**Bureau of Design  
Engineering Computing Management Division**

<p><b>BRADD</b> No. 019 October 31, 2008</p>	<p><b>Incorrect Abutment 2 Bearing Seat Offsets for Box Beam Bridges</b></p>
--	--

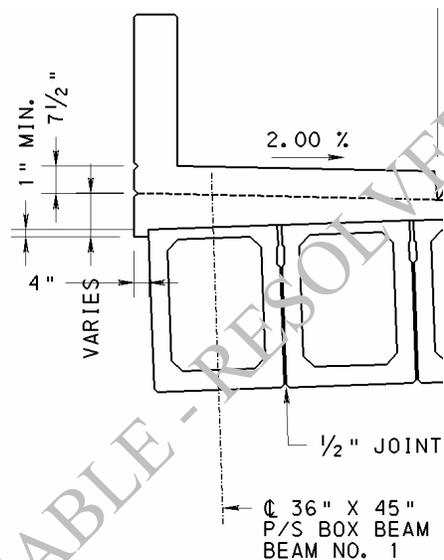
For spread and adjacent box beam bridges, BRADD Version 3.1.3.0 (June 2008) and Version 3.1.3.1 (October 2008) computes incorrect bearing offset values for Abutment 2. The bearing seat offset values are displayed in the following table on the abutment 2 bearing seat elevation drawing.

The problem occurs as BRADD computes the horizontal distance between the location of the top and bottom of the centerline of the box beam due to the transverse slope of the beam. In the figure shown below, the bottom of the centerline of the box beam is shifted to the right due to the transverse beam slope. BRADD incorrectly calculates the shift to the left, but only for the abutment 2 bearing seat offsets. Other calculations that are affected include the width of the cheekwalls, the length of horizontal cheekwall reinforcement bars, and the number of vertical reinforcement bars in the cheekwalls.

For abutment 2 only, manually calculate the bearing seat offsets, width of the cheekwalls, length of horizontal reinforcement and number of vertical reinforcement bars in the cheekwalls, and update the drawings. For abutment 1, the change to use the correct sole plate thickness in the bearing seat offset calculations produces negligible differences, thus the bearing seat offsets for abutment 1 should not have to be manually recomputed. For adjacent box beams bridges with wall abutments, manually calculate the membrane waterproofing quantity.

A fix for this problem is available in version 3.1.3.2. This version can be downloaded as a patch from the BRADD website.
